Date: 27 September 2016 Contact name: Jessica Moran MLA/2016/00227 0203 4518579 Your reference: Telephone:

Our reference: PB2107 Email: jessica.moran@rhdhv.com

Environment Agency comments on WFD Compliance Assessment for Goodwin Sands Aggregate **Dredging Scheme Marine Licence Application**

Plot 1 Showing bathymetry nearest to the dredge area boundary (red line)

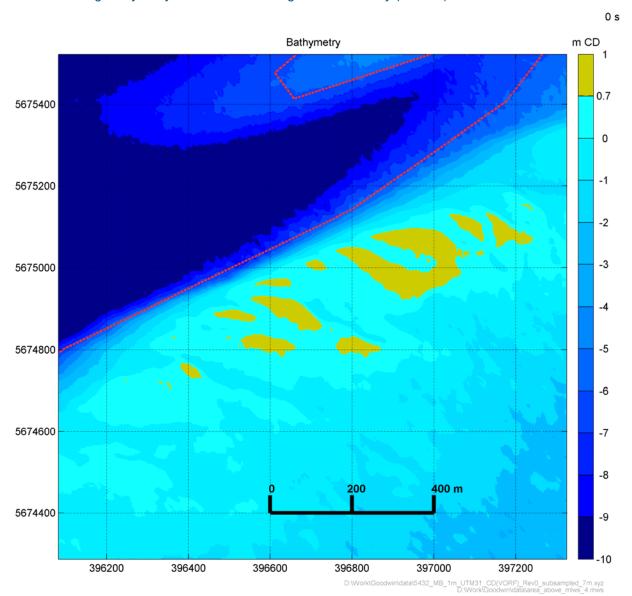
The Environment Agency letter specifically refers to the exposure of Goodwin Sands on certain spring tides and the possibility that intertidal areas could be affected by the proposals. The letter then states "If areas of intertidal are to be dredged, or within 10m of a dredge area, the WFD assessment should screen in hydromorphology for further assessment as per guidance in 'Clearing the Waters'. Please check that hydromorphology should be screened out and provide evidence to justify".

To provide further evidence of this, HR Wallingford have produced two plots showing the level of MLWS, (taken from Deal on the Kent coast) on South Goodwin Sands which is 0.7m above Chart Datum against the dredge boundary on bathymetry data collected in 2015 (for detail on the bathymetric survey please refer to **ES Appendix 2.1 - Dredge Area Site Selection, Sections 1.3-1.4**). Deal is considered to be the most appropriate reference point as it is the nearest point on the coast to the site (approximately 7km to the west of the dredge area) and because the lines of equal tidal range are generally east to west into the Dover Straits.

Plot 1 shows the nearest area with bed levels recording higher than 0.7m above Chart Datum (and therefore above MLWS). These areas are shaded green and the dredge boundary is coloured red. The measurement taken from this plot shows that the dredge boundary is at least 60m from the green shaded areas. **Plot 2** shows the same information but for the entire dredge boundary.
